## ADDENDUM No. 3

### RFP No. 22-76

#### East Medical Center Drive Bridge Rehabilitation and Widening Project

**NOTES:**

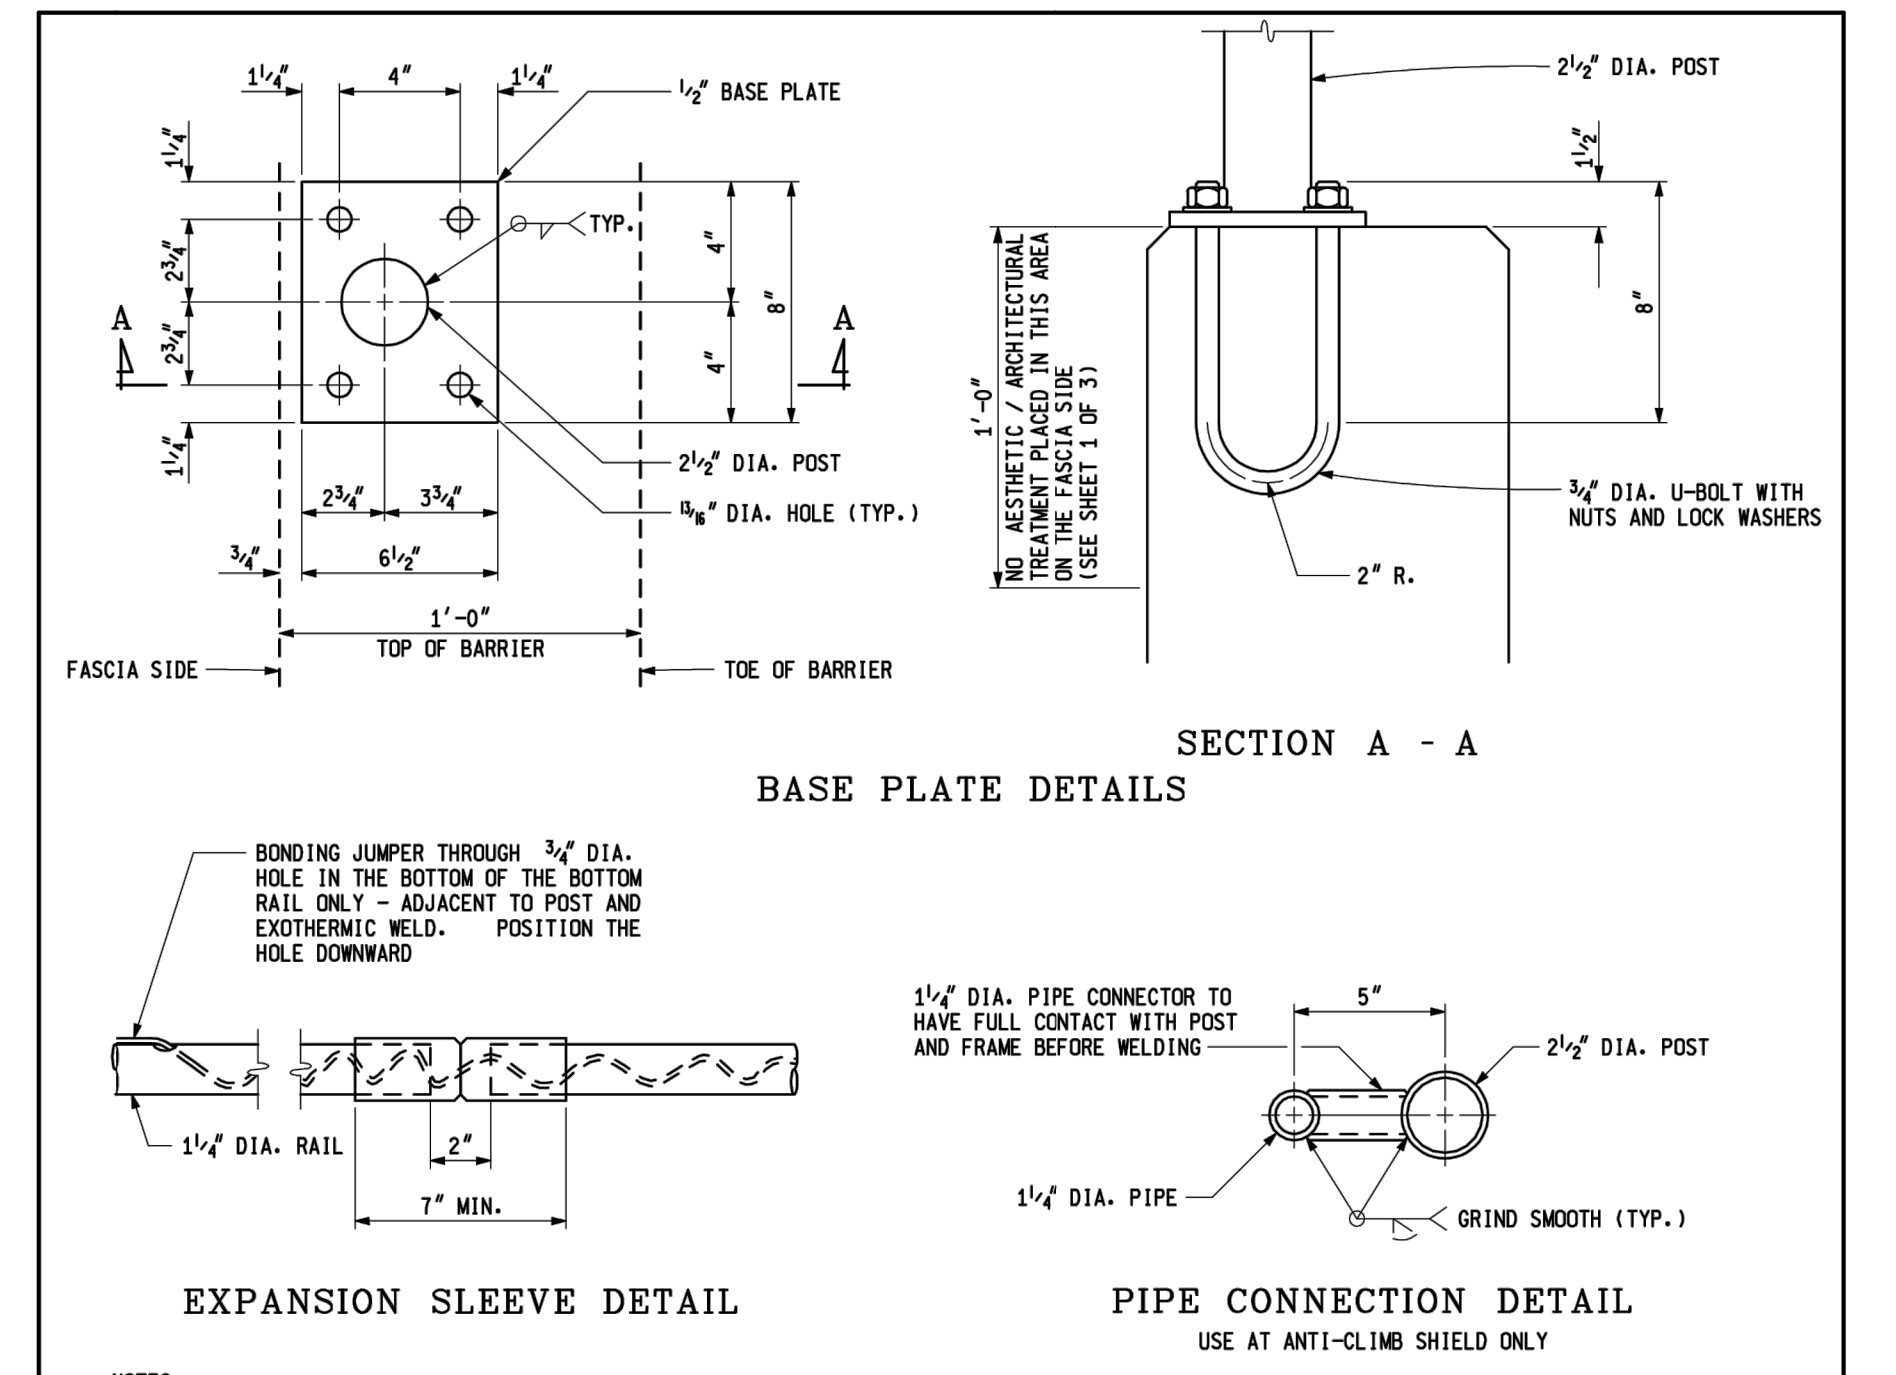
RFP\_22-76\_Plans Sheet 134A MDOT Standard Plan B-41-C Fencing for Bridge Railing, Aesthetic Parapet Tube was added to the plans.
